Record of Decision

General Electric Main Plant Site

Operable Units No. 03 and 04

March 2005

FIGURE 12	GROUNDWATER FLOW FILL AND FLOODPLAIN AQUIFER
	GENERAL ELECTRIC COMPANY MAIN PLANT SCHENECTADY, NEW YORK
	646 PLANK ROAD SUITE 202 CLIFTON PARK, NEW YORK 12065

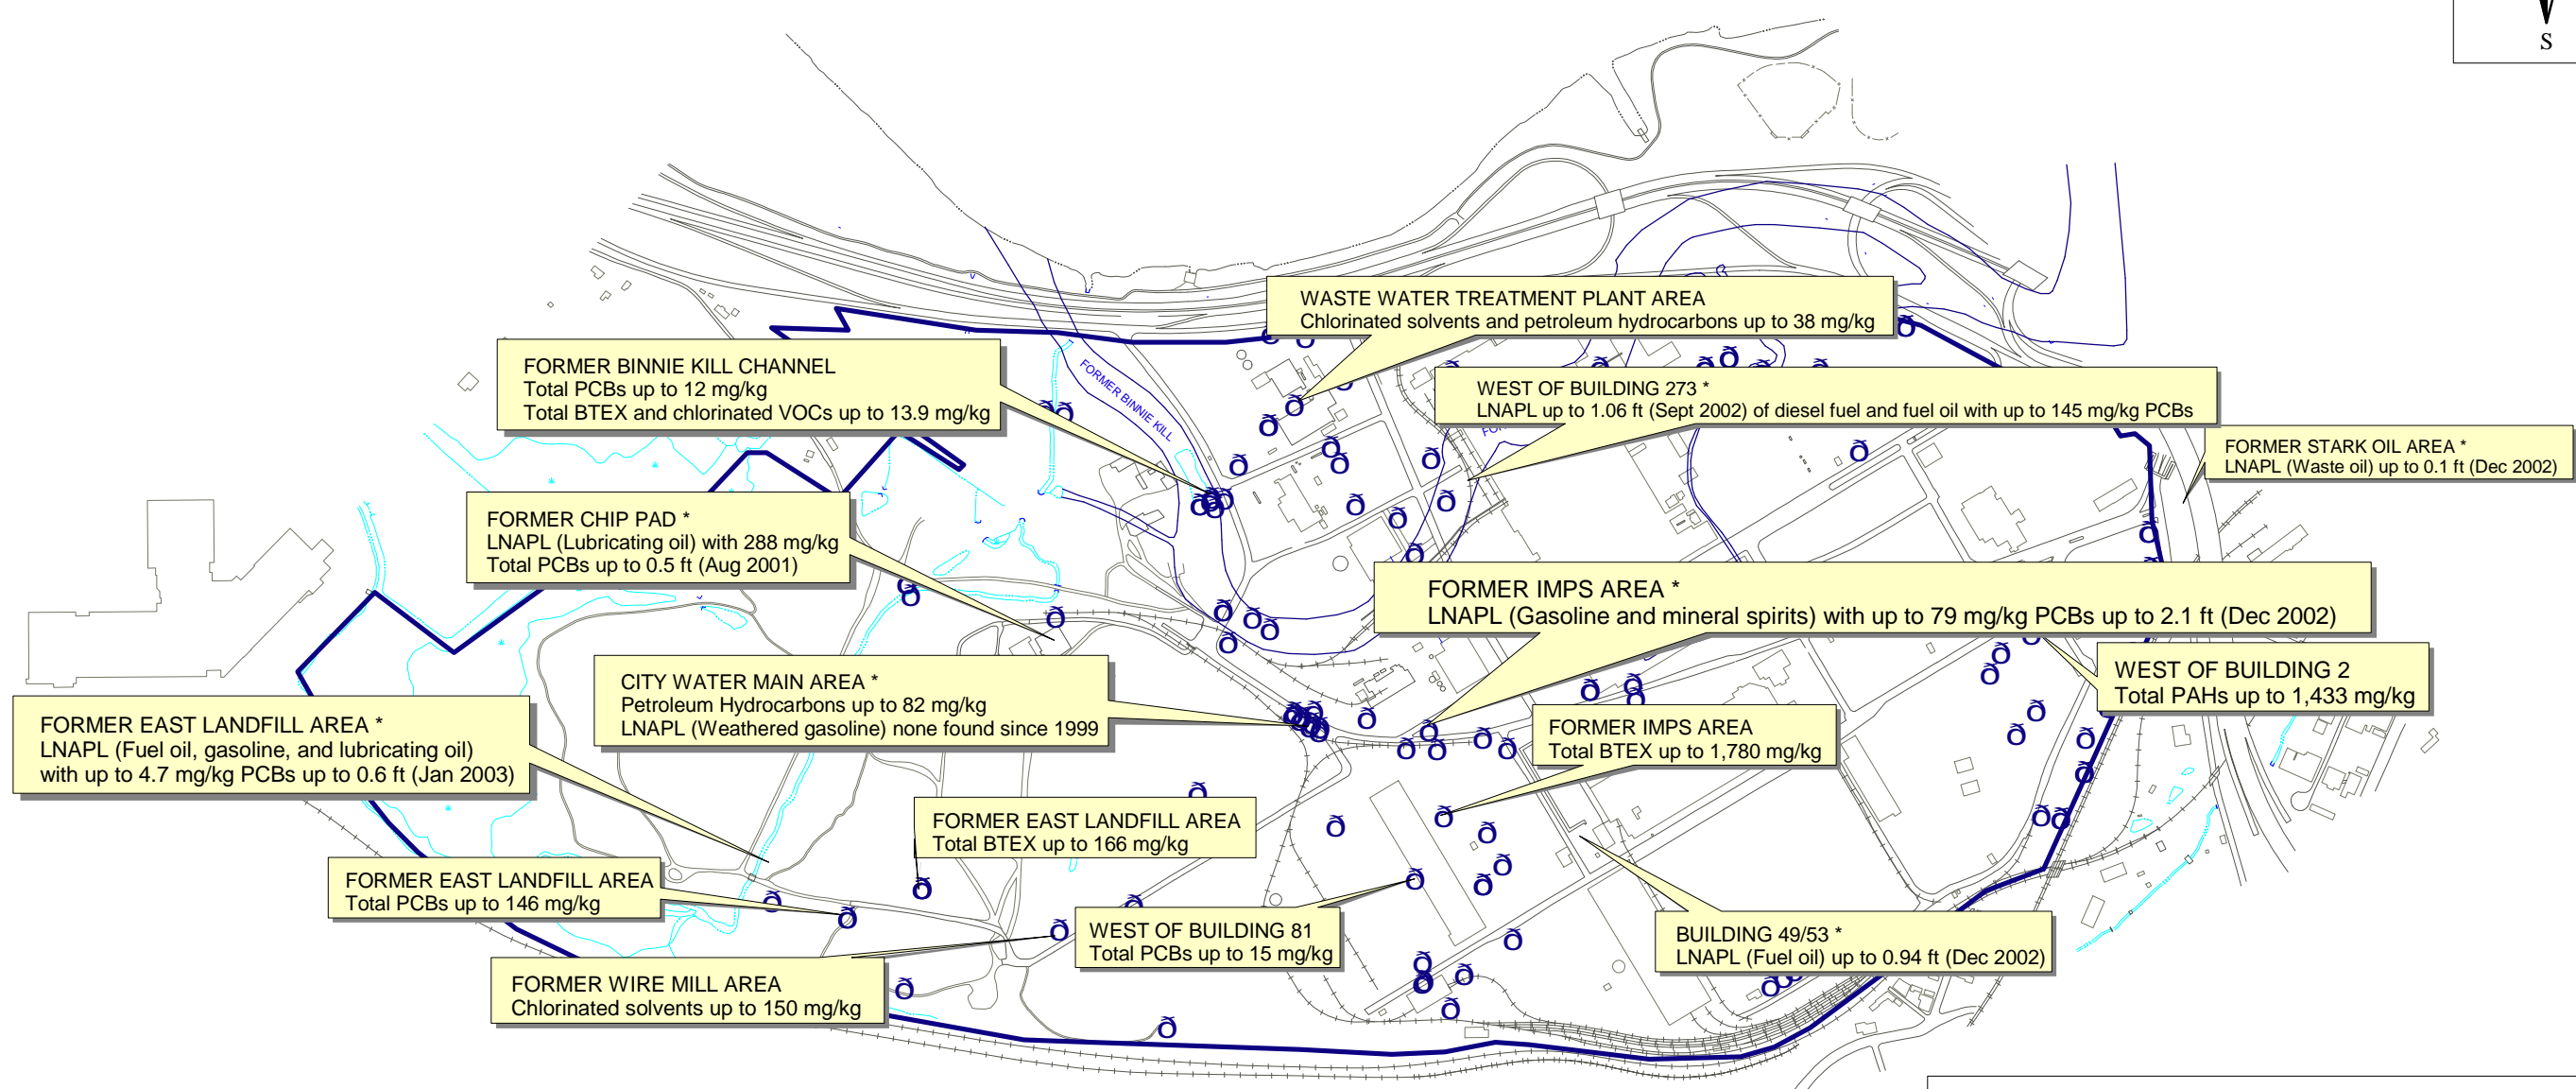
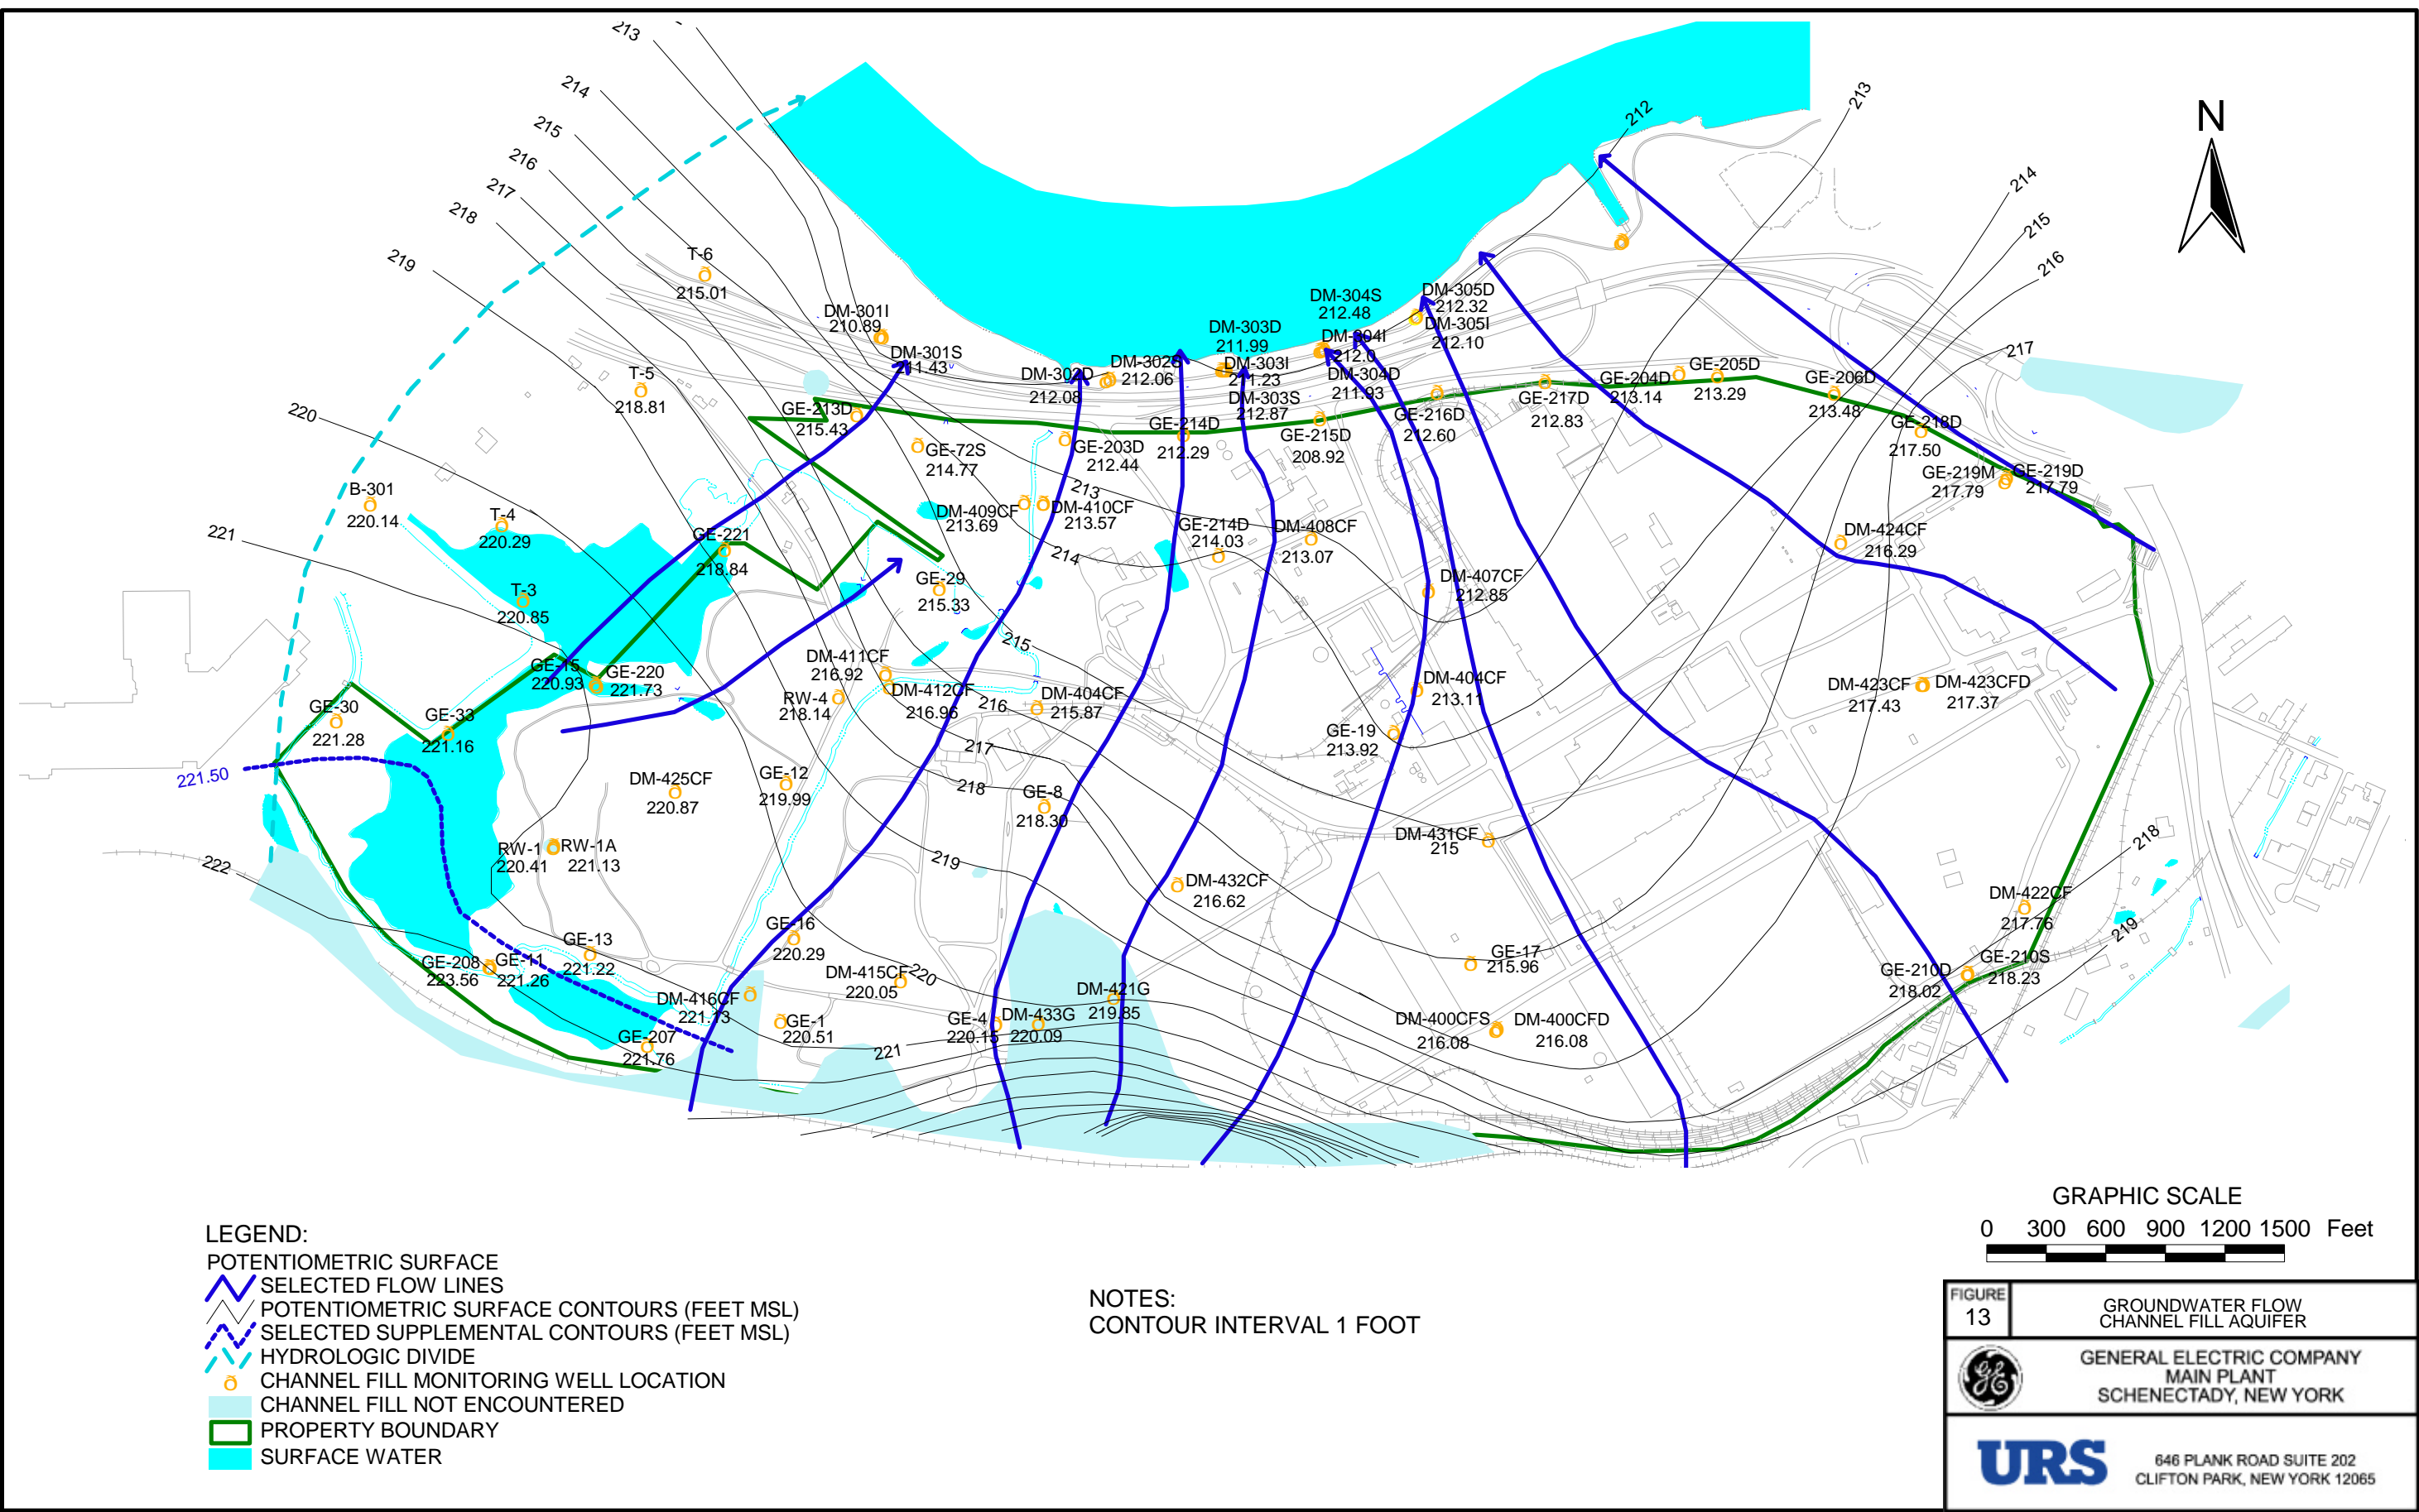
Comment 61: *Page 3, 4. - However, water-table contours (fig. 12) are consistently a foot or more higher than potentiometric contours in the channel-fill aquifer (fig 13) all across the GE property. If this condition obtains at most times throughout the year, as I would expect, there must be a downward gradient, so I would expect most contaminants (other than LNAPLs) in the shallow sediments to migrate downward into the channel-fill aquifer*

FIGURE 16

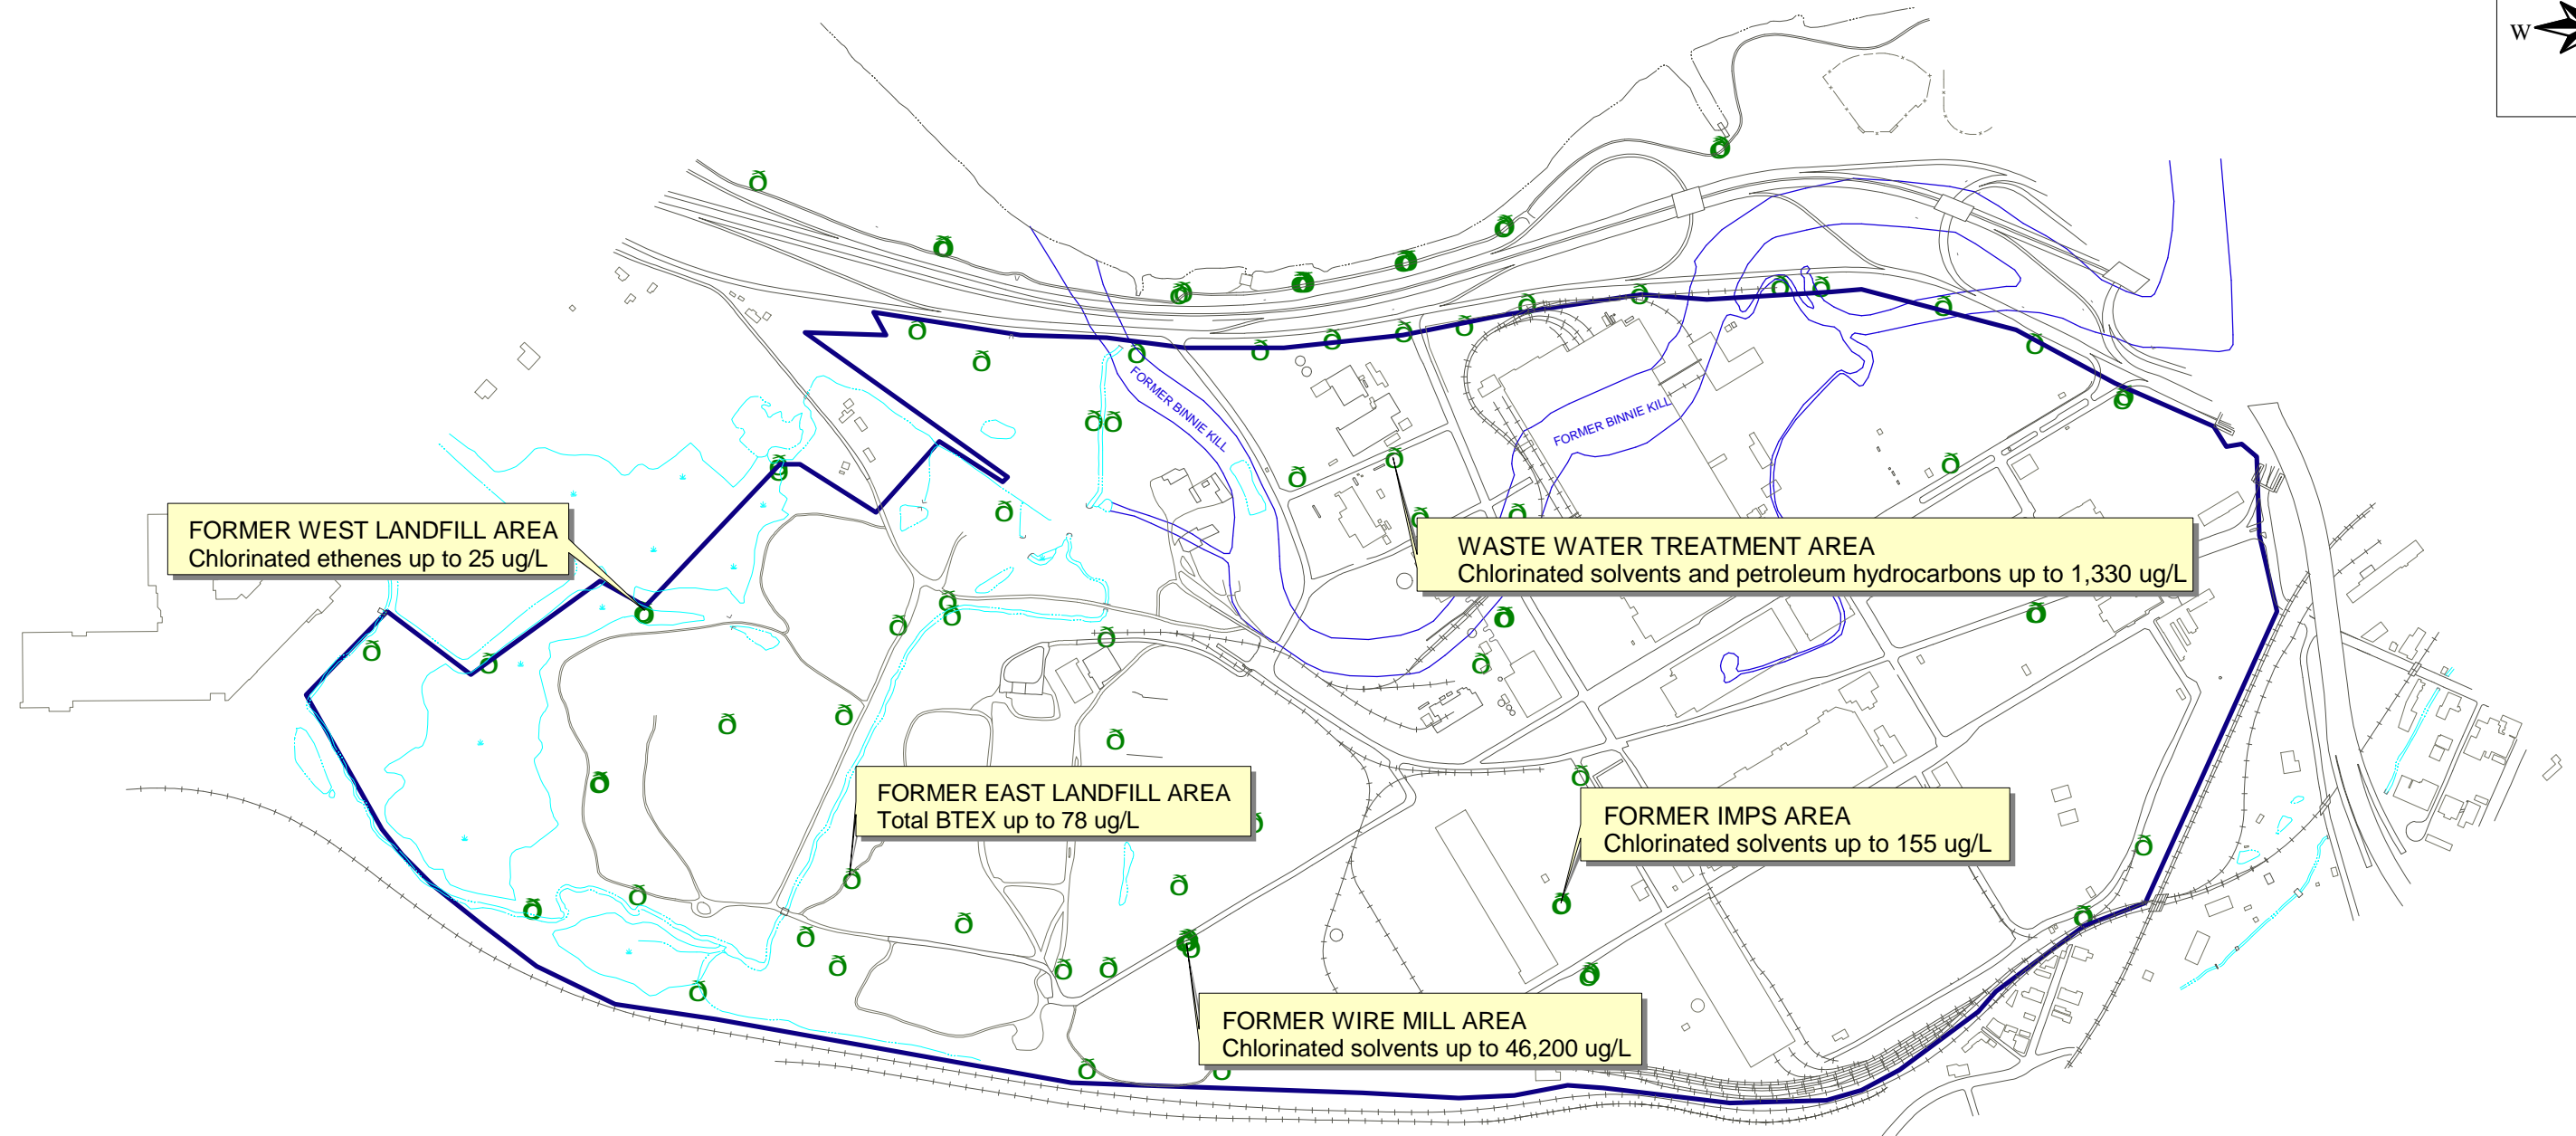
Comment 52: *Page 3, 3rd Paragraph - The PRAP on page 14 states that the extent of the ground-water contamination in the fill/flood plan and channel-fill aquifers is shown in Figures 16 and 17. We do not find it clearly shown and would like more in depth proof of the extent of the ground water contamination.*

Response 56: The intent of the figures (16 & 17) included in the PRAP were to provide a general, high-level summary of the multitude of investigative data and results from the RI program. Specifically, Figures 16 & 17 illustrate the locations and results of higher concentrations of contaminants detected during the RI program including representative locations within the groundwater for the corresponding geologic depositional layers. For a detailed summary of detected and non-detected constituents, including better illustrations of sampling locations, please refer to the *Revised RI Report*.
